Invitation to Bid: Construction Fire Station

49 Addendum 11

November 21, 2025

This is a cumulative response for architectural, structural, mechanical, electrical, plumbing and fire protection RFI's submitted to date.

E1.3

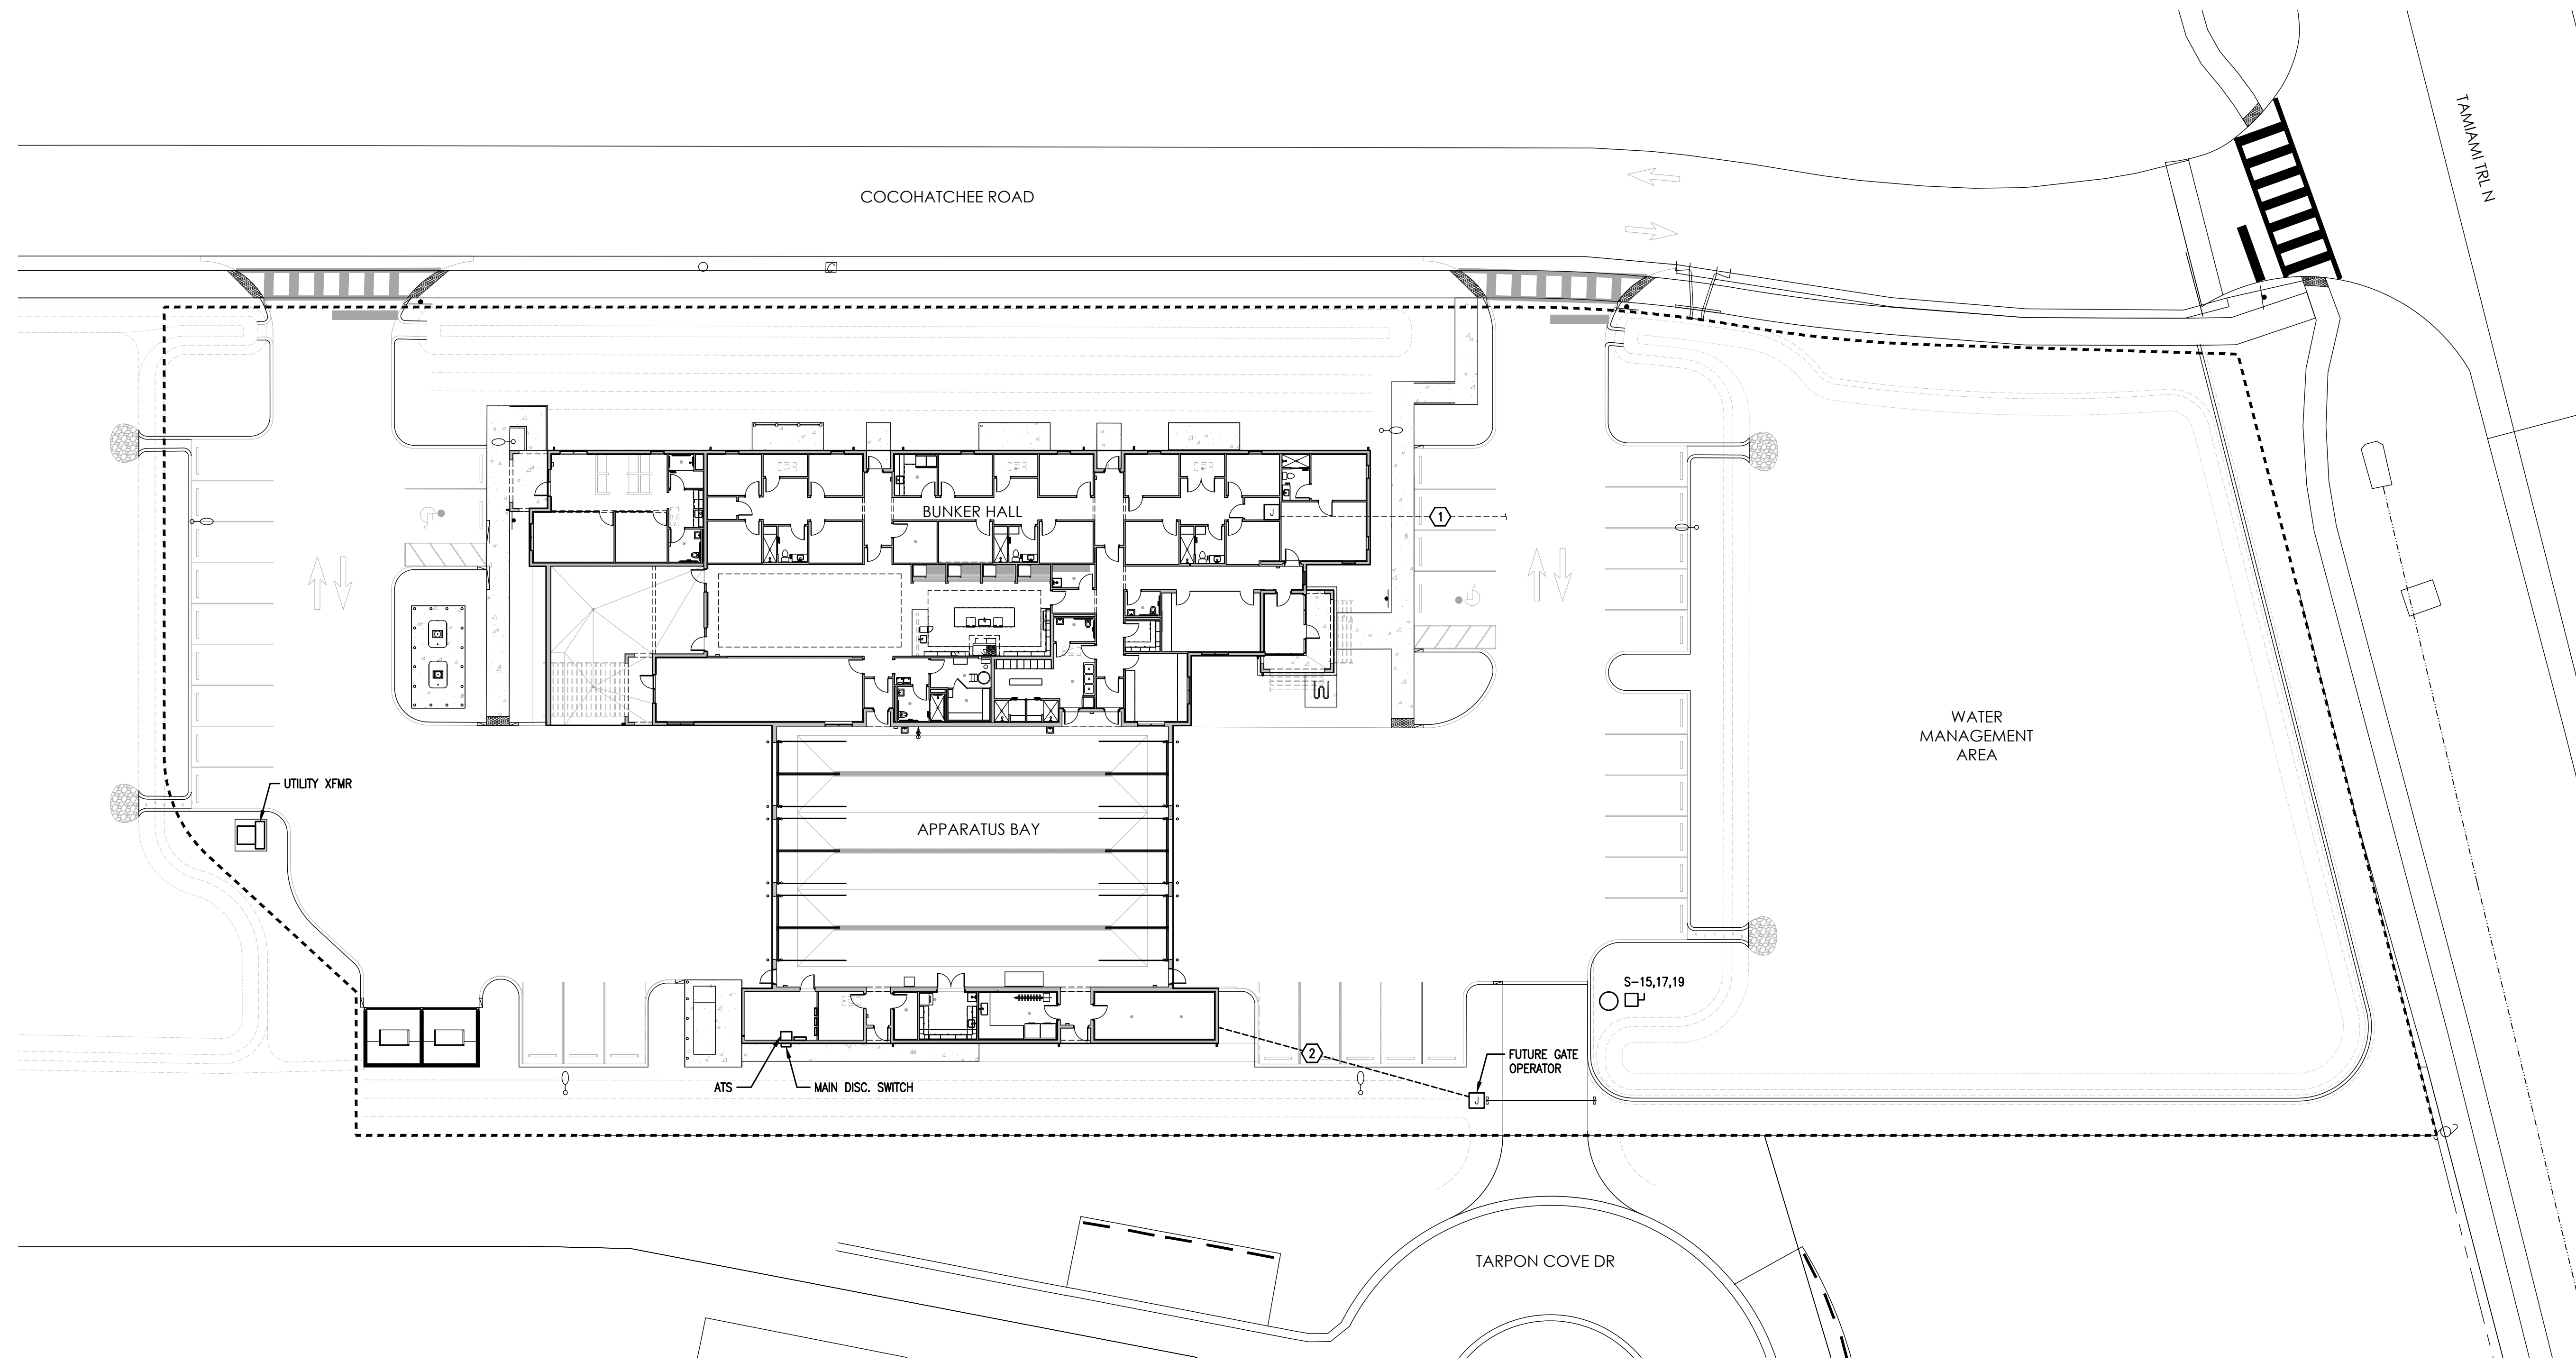
- **See Previous RFI Responses**
57. Please clarify the specifications for the under-cabinet lighting reference on sheet A6.2 detail 1 (Open office elevation #1).

- **The fixture H can be used in all under counter lighting such as in the kitchen, office break room, and EMS storage. See revised sheets E1.2 & E1.3. The plan set shall be revised.**
